**TENNESSEE VALLEY AUTHORITY
BROWNS FERRY NUCLEAR PLANT**

**EXTENDED POWER UPRATE
CREDIT FOR CONTAINMENT OVERPRESSURE**

July 18, 2007

UNIT 1 105% ACRS

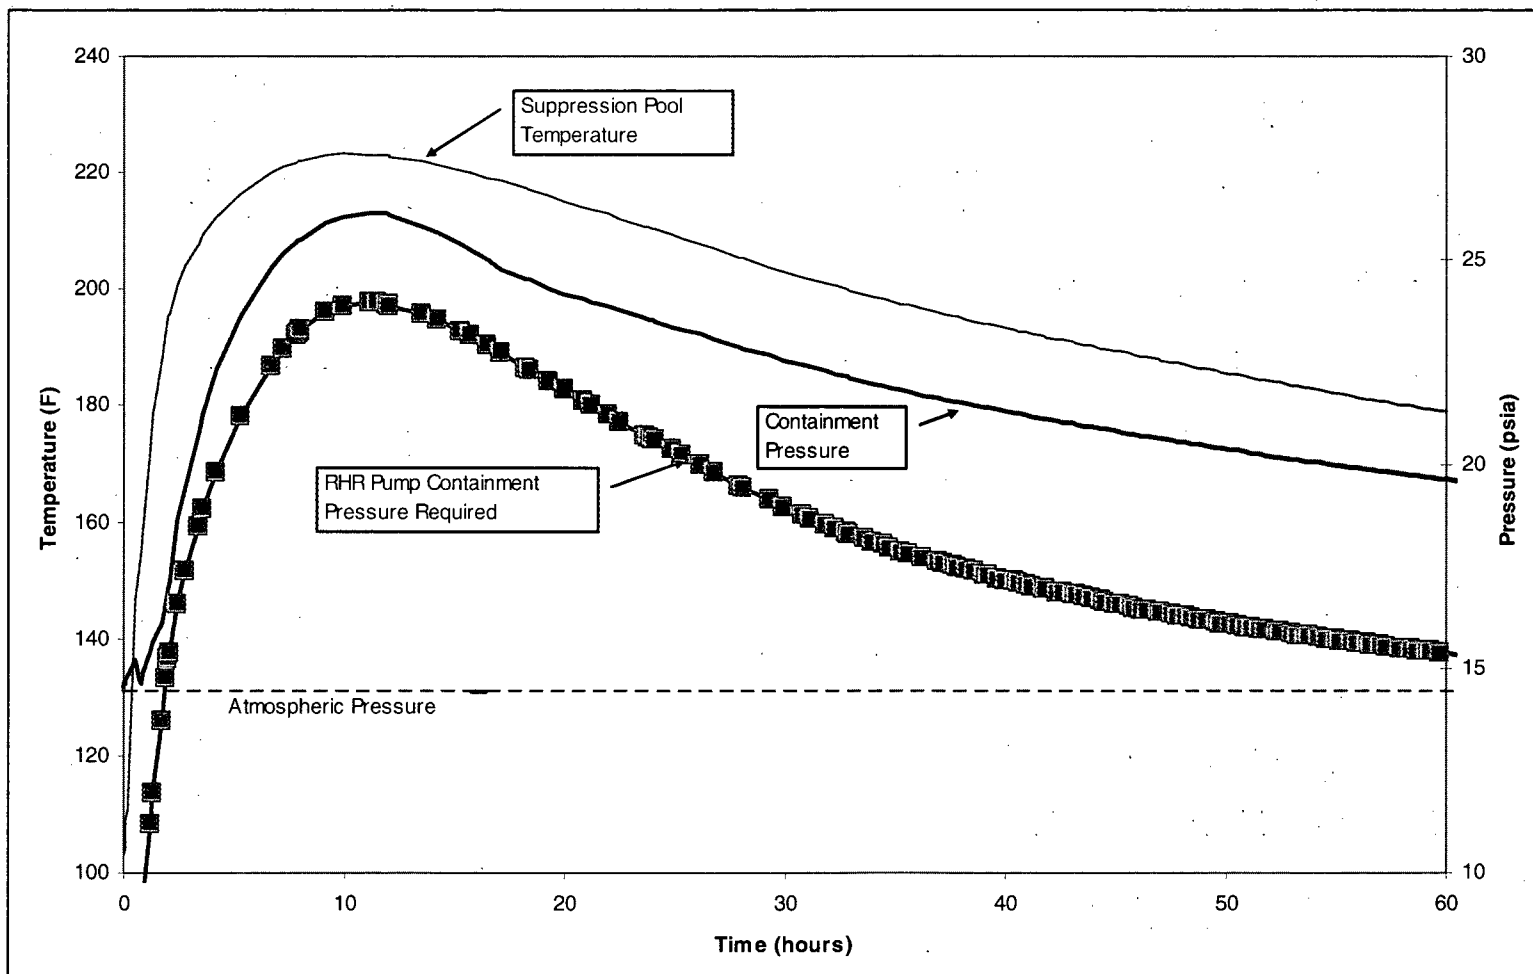
- ACRS LETTER 2/16/07
 - Agreed with COP for all but APPENDIX R event

Although the thermal-hydraulic evaluations for this scenario are intended to be realistic, the licensee argues that this is an overly conservative scenario, because more equipment is likely to be available than postulated in the scenario. If two or more RHR pumps are available, credit for containment overpressure is not needed.

Because of the plant configuration, the extent of modification required, and the worker dose that would be involved, we conclude that there are no practical design modifications that would preclude the need to consider the request for containment overpressure credit for most of the scenarios. However, for the Appendix R scenario, protecting a second RHR pump would eliminate the need for the credit and may be a feasible alternative.

Because of the amount of time for which credit is required and the amount of credit required, the Appendix R fire scenario is the limiting event for which containment overpressure credit is required. The staff presented a risk evaluation of containment overpressure credit for this scenario that showed that the contribution to core damage frequency associated with this scenario is small and represents a small fraction of the BFN1 core damage frequency. However, this assessment did not include fires initiated by external events, such as earthquakes and tornados. The inclusion of these initiators in the risk evaluation is likely to increase the risk associated with the Appendix R scenario. To use risk arguments to justify overpressure credit for this scenario, the licensee and the staff need to provide a more complete analysis including all initiators. Because of the smaller amount of credit required for operation at 105-percent power, this extensive analysis is not needed to support operation at that power level.
